UNITED STATES PATENT AND TRADEMARK OFFICE

Office Action Summary

10/784,316

SWANSON ET AL.

FIG. 4

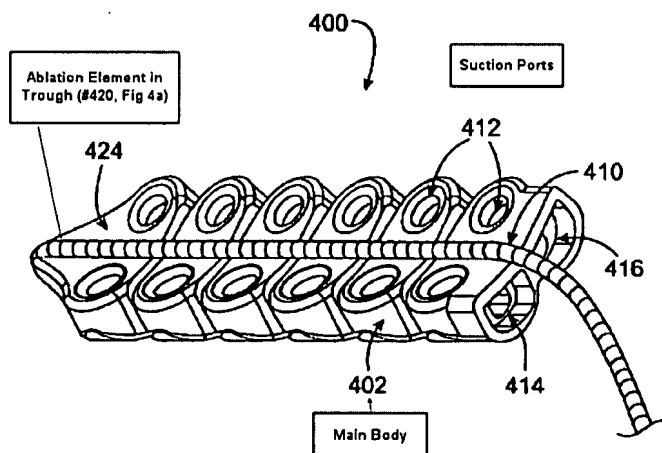
Claims 1-11, 13-27 and 29-38 are rejected under 35 U.S.C. 102(e) as being anticipated by U.S. Patent 6,849,075 to Bertolero. Bertolero et al. teach a device for holding an ablation (electrophysiology) device including a trough (Fig. 4a, # 420) wherein the ablation member (Fig.

4, # 410) may be a removable piece which may be removably attached to tissue contacting member (Fig. 4, # 402), at least partially disposed within a trough (Col. 16, lines 44-54). The ablation element is interpreted as an operative element. Multiple suction ports (Fig. 4, # 412) are disclosed, the area with the ports is interpreted as a bottom surface. The

ports are clearly longitudinally spaced. The trough is interpreted as a connector. The area around the ports can be interpreted as a wall and the bottom area is broadly interpreted as a suction region. Some means is required to connect the suction ports to the suction lumen, such connection interpreted as an aperture. The suction lumens are connected to a suction source via suction lines (Fig 6). The tissue contacting member is of a flexible material (Col. 16, line 3), implicitly making the suction apertures flexible and the trough (connector) flexible. Bertolero et al. disclose cooling of the ablation device by a cooling member with fluid inlets and outlets that allow passage of fluids from the ablation device, the ablation device inherently must have complementary lumens and fluid outlets to allow such passage (Claim 71). That passage would be within the connection trough.
